DEVELOPMENT ASSESSMENT REPORT	
Application No.	DA/2020/0477
Address	85 Hill Street LEICHHARDT NSW 2040
Proposal	Boundary realignment of two existing Torrens title lots, and construction of two X two storey semi-detached dwellings
Date of Lodgement	23 June 2020
Applicant	Blu Print Designs Pty Ltd
Owner	Ms Marta Levanec James Ardagna Santo Ardagna
Number of Submissions	One
Value of works	\$680,000.00
Reason for determination at Planning Panel	Minimum lot size variation exceeds officer delegations
Main Issues	Undersized lots
Recommendation	Approved with Conditions
Attachment A	Recommended conditions of consent
Attachment B	Plans of proposed development
Attachment C	Clause 4.6 Exception to Development Standards

This report is an assessment of the application submitted to Council for boundary realignment of two existing Torrens title lots, and construction of two X two storey semi-detached dwellings at 85 Hill Street, Leichhardt.

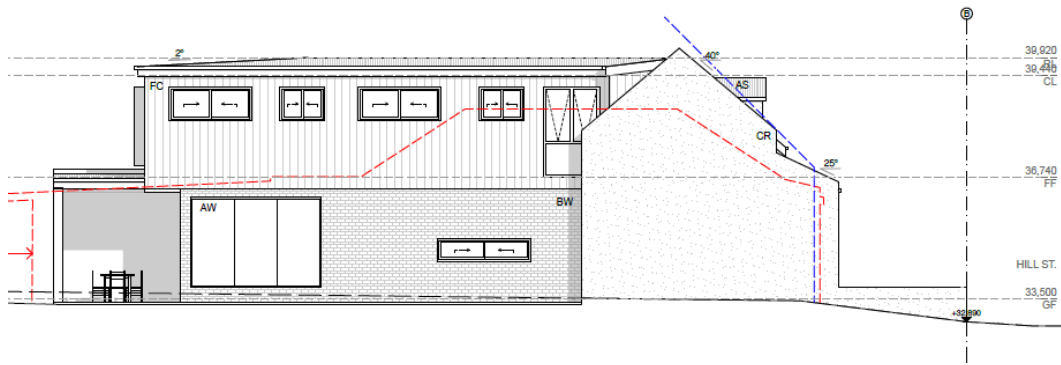
"There are no objections to the application in general as no trees were assessed to be negatively impacted by the proposal. The applicant is encouraged to incorporate a more diverse palette of canopy tree species in the landscape that will attain a minimum mature height of 6m."

As such an appropriate condition will be imposed on any consent requiring a minimum of 4 x 75 (L) litre sized canopy tree which will attain a minimum mature height of six (6) metres be planted in accordance with submitted Landscape Planting Plan, prepared by Michael Siu.

The proposal will be conditioned in accordance with the above. The application is considered satisfactory having regard to Landscaping and Tree Management.

North Elevation
1:100

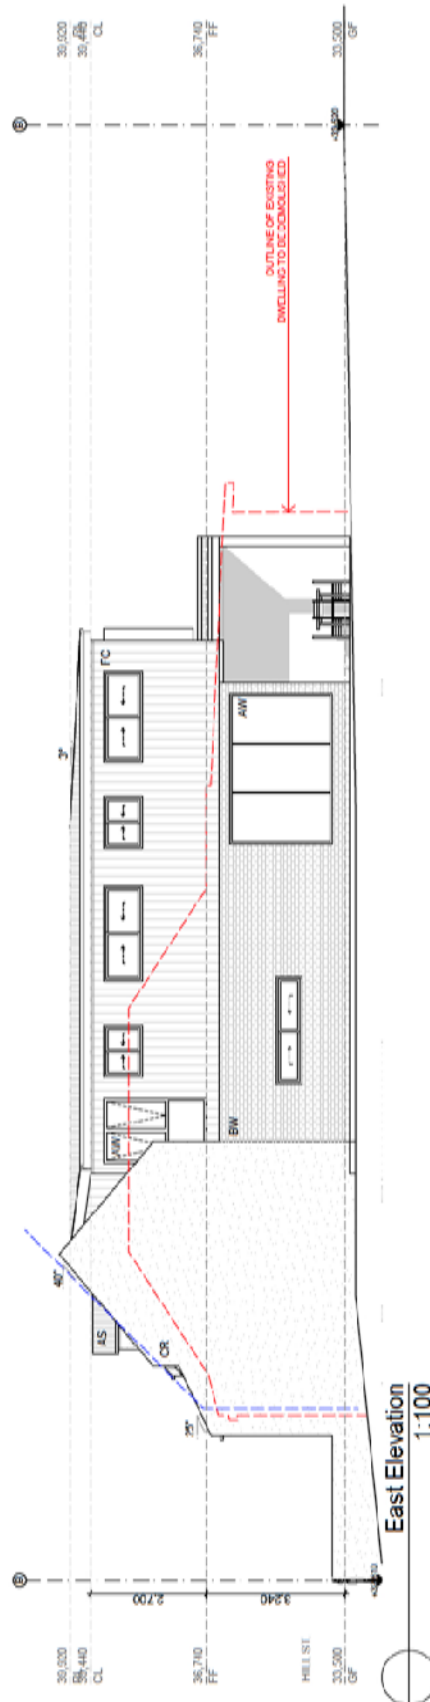
The development proposes one single dormer per dwelling to the front elevation. Whilst a single dormer (per dwelling) is supported, it is considered that the proposed dormers should be vertically in proportioned consistent with other openings to the front elevation and those of front dormers characteristic of the streetscape and wider area. As such, a condition will be included requiring the height of dormers to be increased so that they are vertically proportioned – in this regard, the following design change condition is recommended:

Prior to the issue of a Construction Certificate, the Certifying Authority must be provided with amended plans demonstrating the following amendments to front facing dormers:
